CITY OF KIRKLAND
Planning and Building Department
 123 5th Avenue, Kirkland, WA 98033
 425.587.3600 - www.kirklandwa.gov

**ADVISORY REPORT
 FINDINGS, CONCLUSIONS, AND RECOMMENDATIONS**

File: **VAR18-00070**
MARKET STREET DENTAL CLINIC VARIANCE

Drawing Number:
VAR1.1

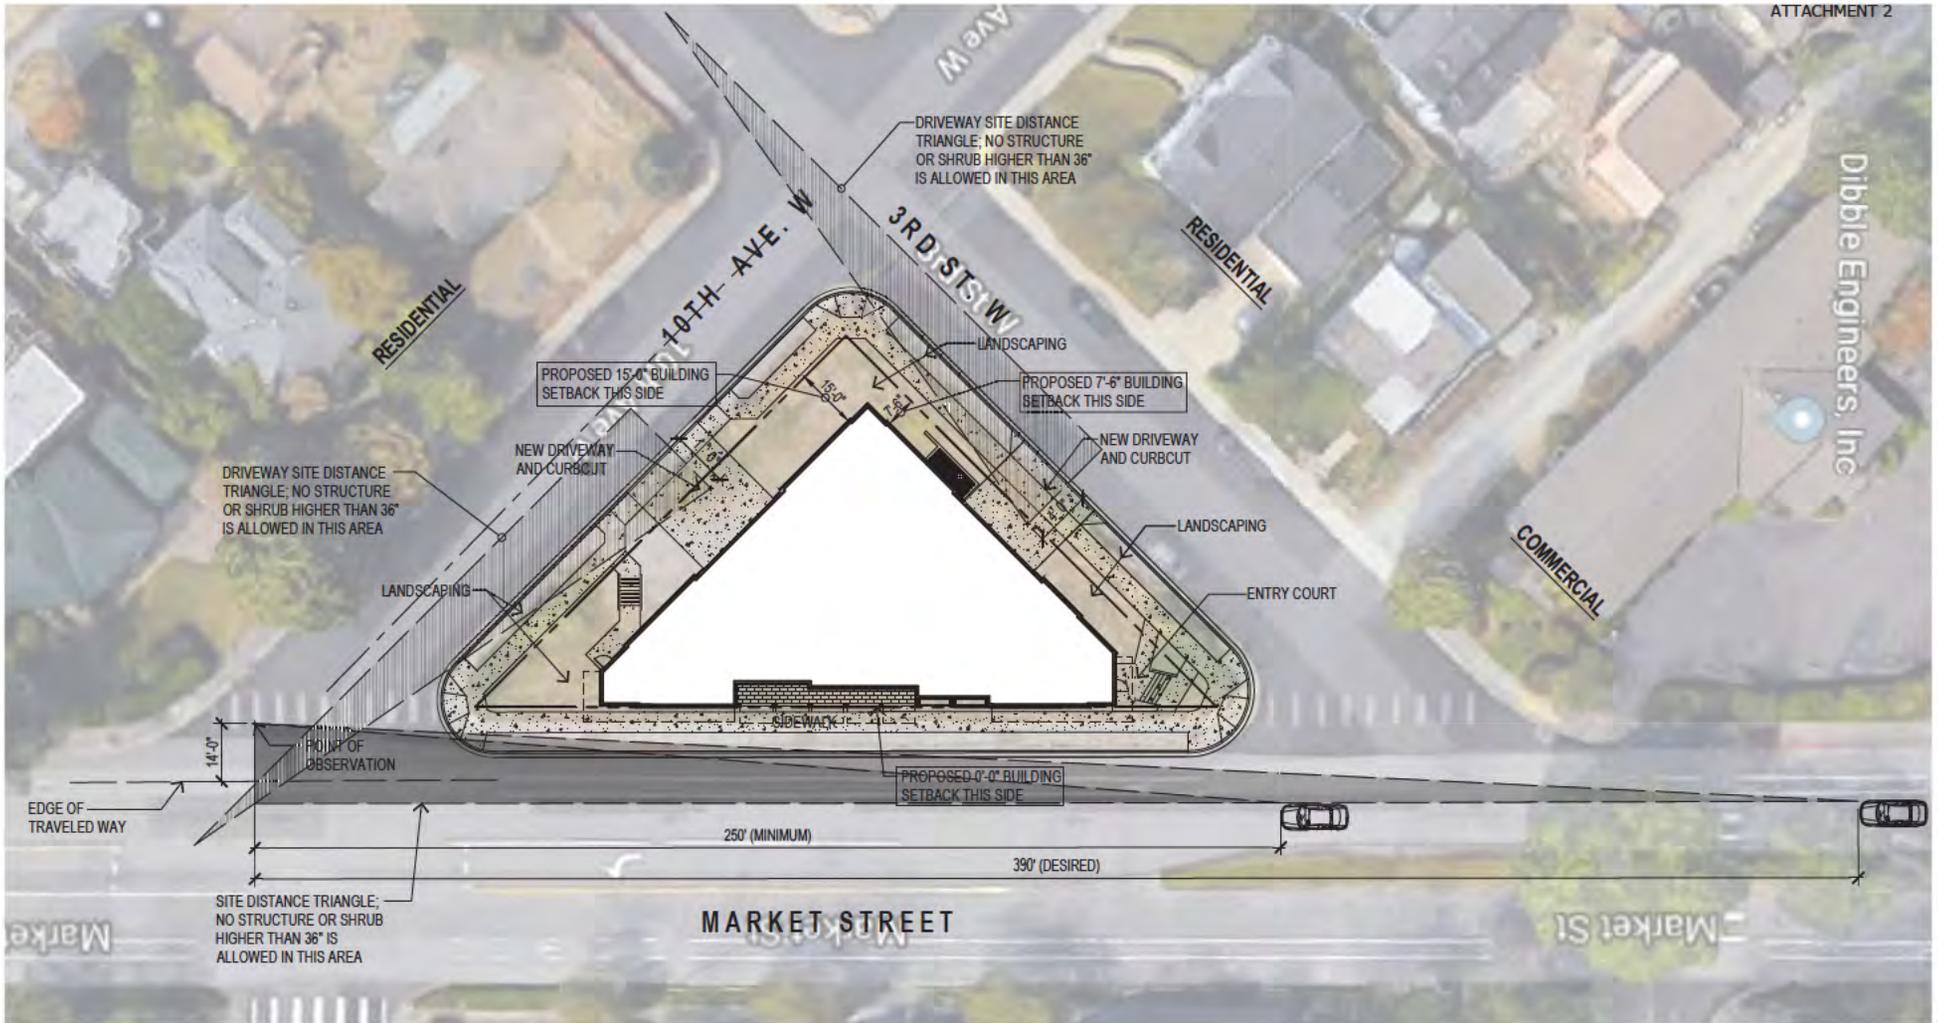
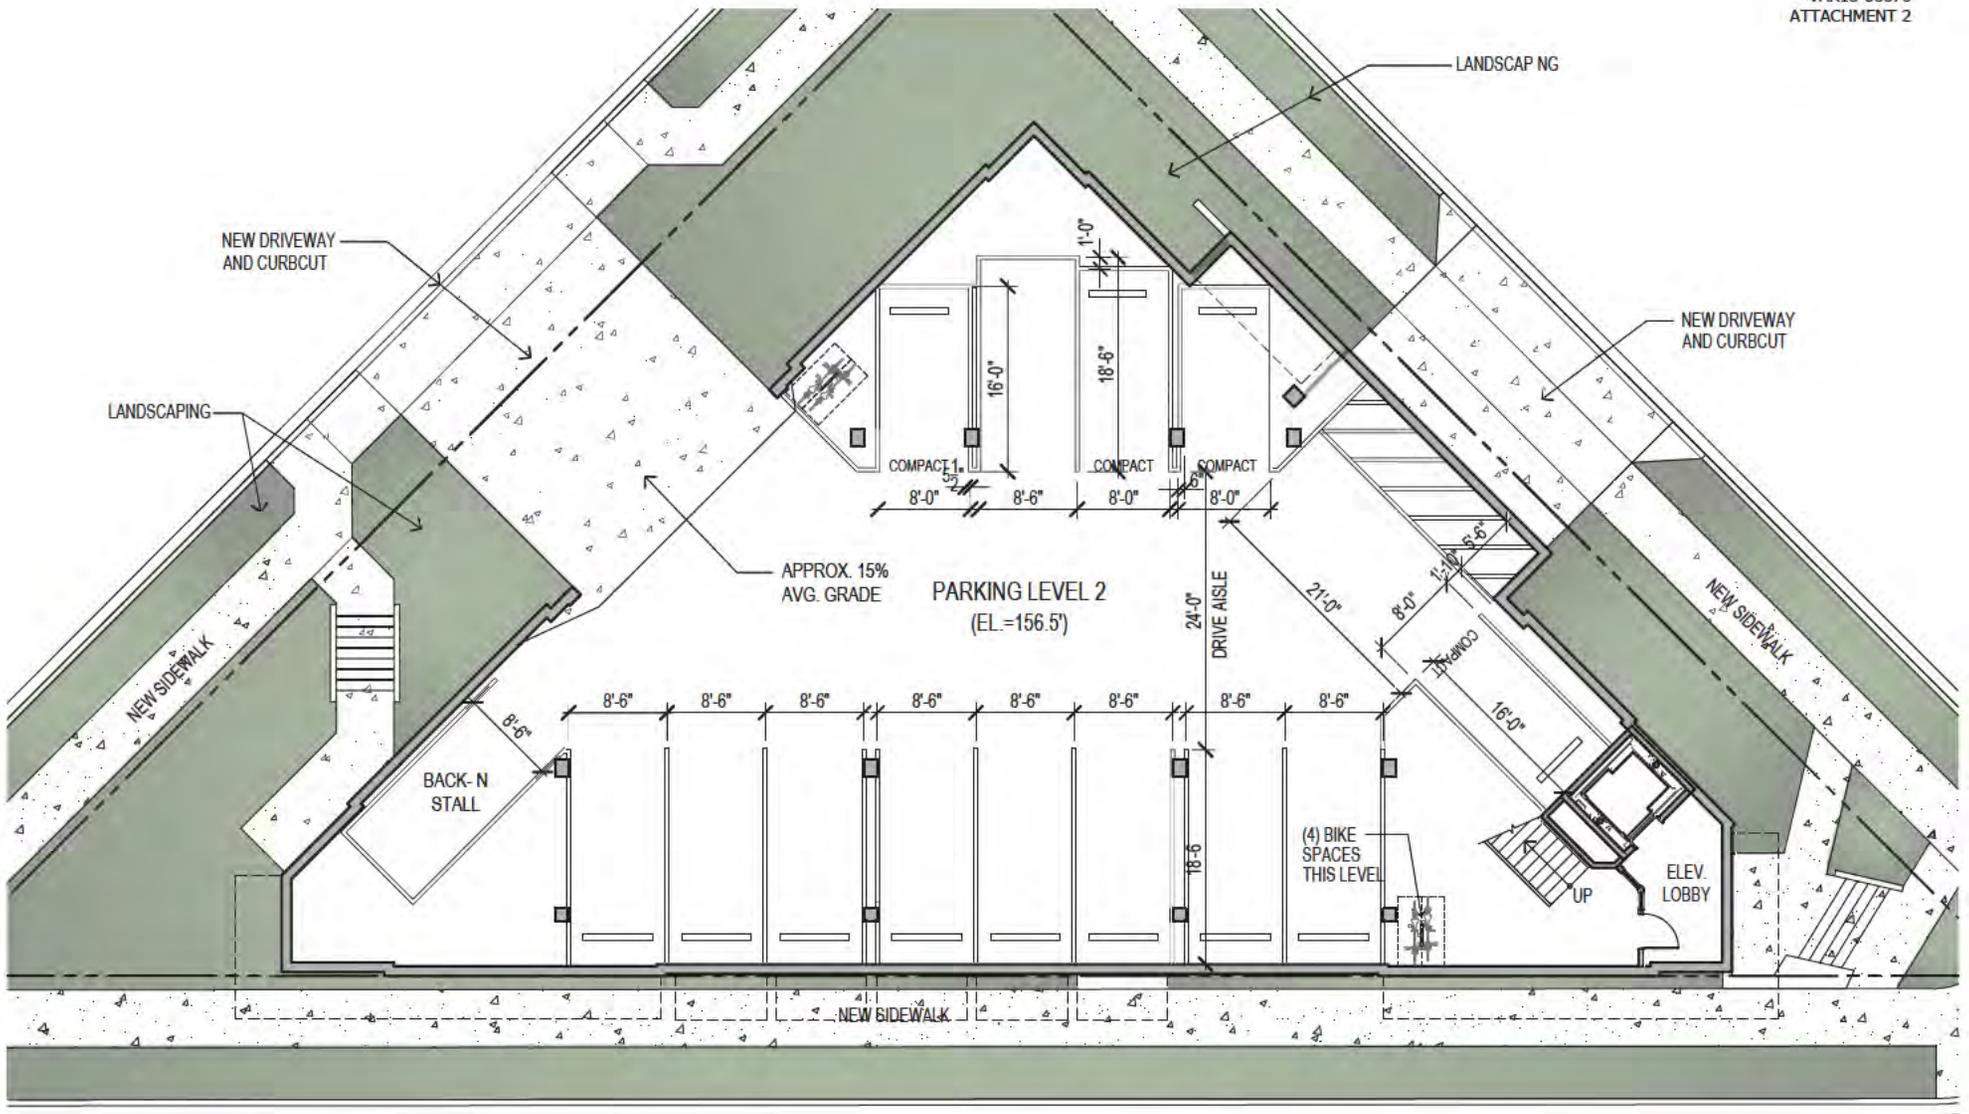
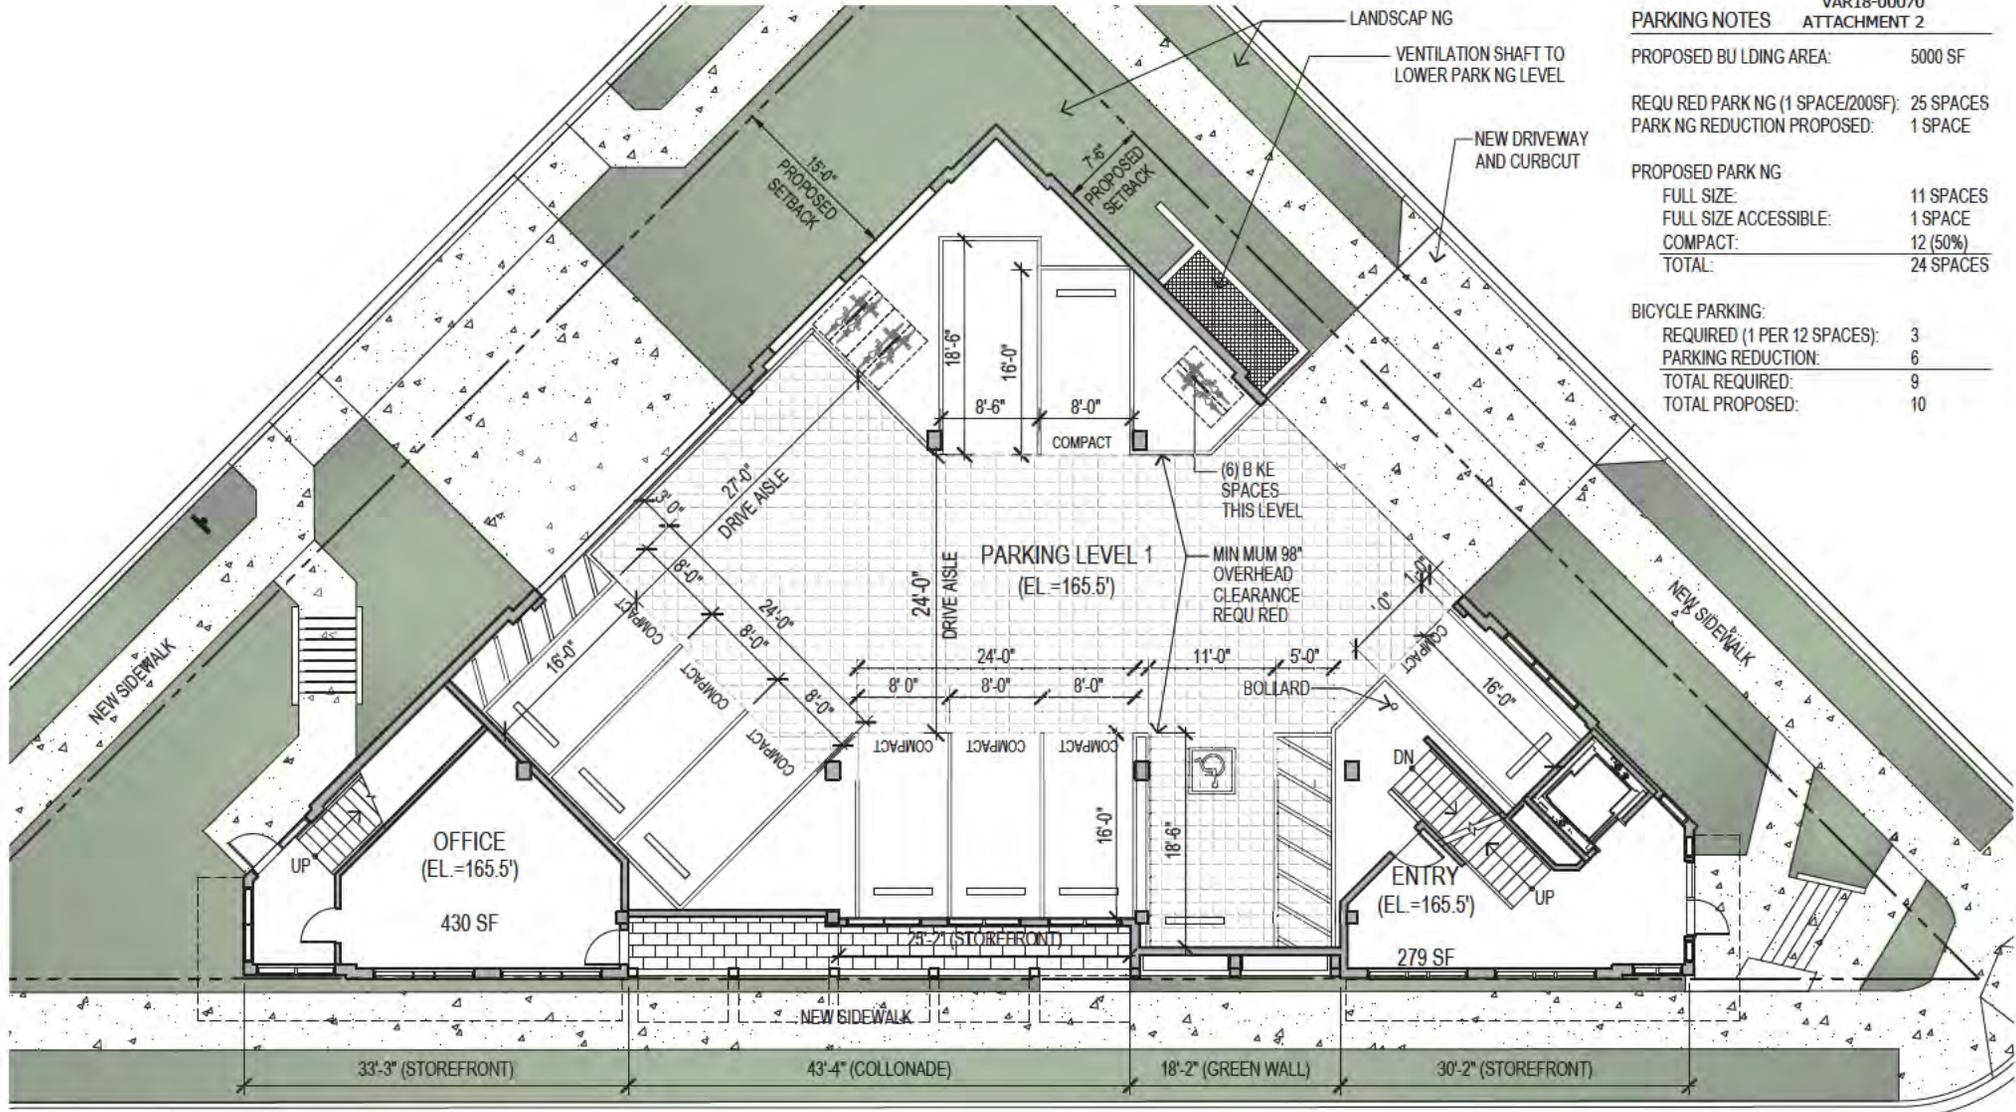
- (1) Some neighbors are concerned about impacts from the driveway and intersection sight distance issues.
- (2) **Staff Response**: The project site design was reviewed by the City's Transportation Engineer who concluded that the project required a driveway variance to allow two access driveways, instead of one, to the site (one from 10th Avenue West and one from 3rd Street West) and to allow the driveways to be less than 75 feet from the adjacent intersections (see Section II.E.5).

Additionally, Public Works Pre-Approved Plan Policy R-13 specifies sight distance requirements for driveways and various types of intersections. These guidelines establish the sight distance triangle that must be kept clear of sight obstructions for all intersections and driveways pertaining to new developments.

Figure 1. Site Plan

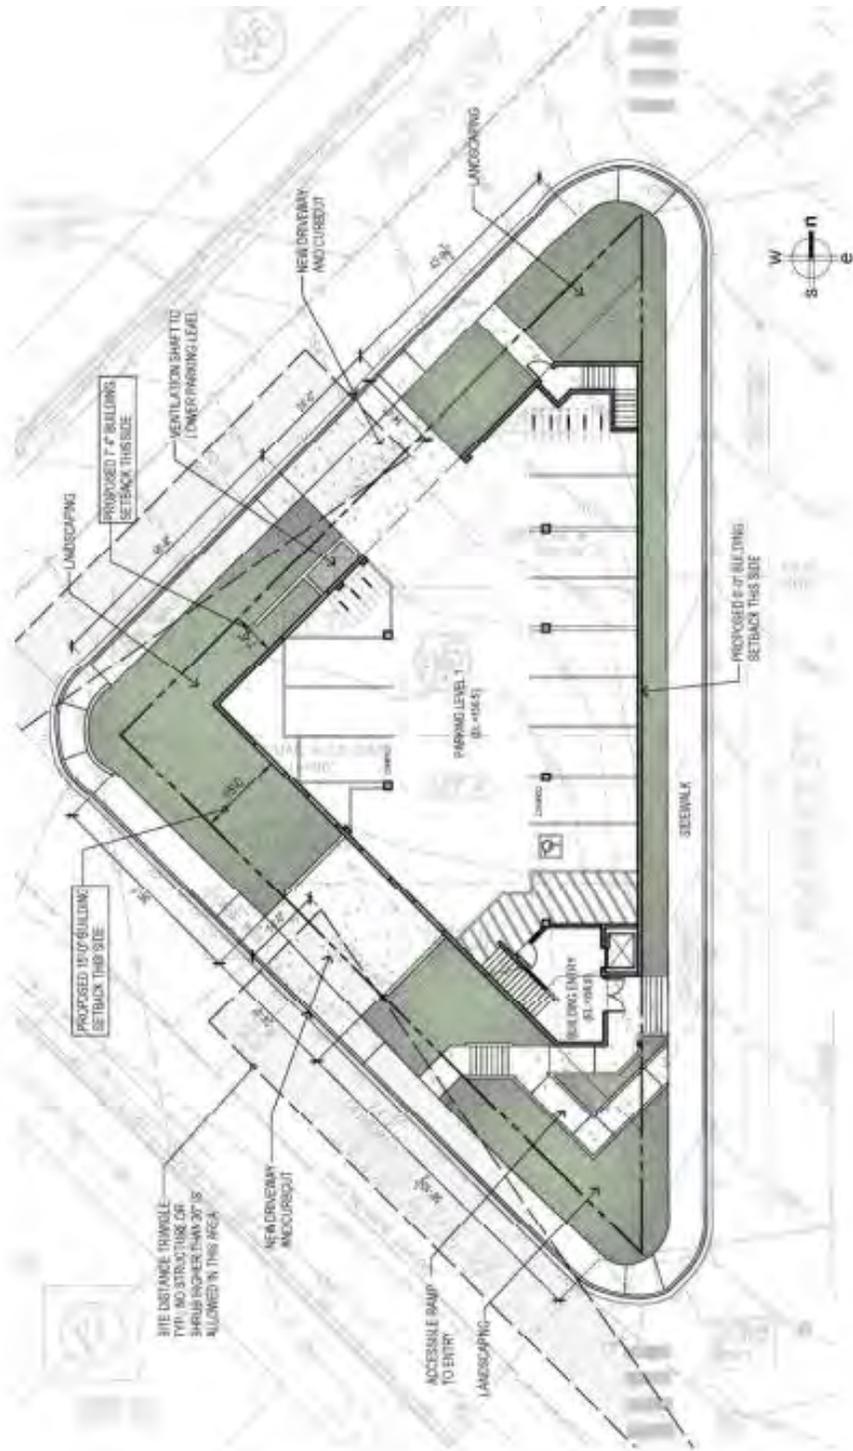
1. Allow two driveways to serve the development as shown in Figure 1.
2. Allow both driveways to be located less than 75 feet from the adjacent intersections.

The minimum length along a property frontage required to meet the driveway-to-intersection spacing is 224 feet. The property frontages along 10th Avenue West and 3rd Street West are approximately 144 feet. Therefore, it is not possible to meet the driveway-to-intersection spacing requirement. The City of Kirkland is required to allow access into the property. As indicated above, there is sufficient sight distance at the proposed driveway. Both streets where the driveways are proposed has a speed limit of 25 mph. With low speed, low traffic volumes, and clear sight distance, it is anticipated that the driveways would operate safely.

4. Public Works Staff has reviewed the request for a driveway variance and approved the project driveways with the following conditions (see Conclusion II.E.5):

- a. Paint the curb east of the project driveway red to restrict on-street parking east of the project driveway on 10th Avenue West.
 - b. All landscaping and structures within the sight triangles for both driveways must be no higher than three feet measured from the grade of the driveway located 14 feet back from the back of the sidewalk.
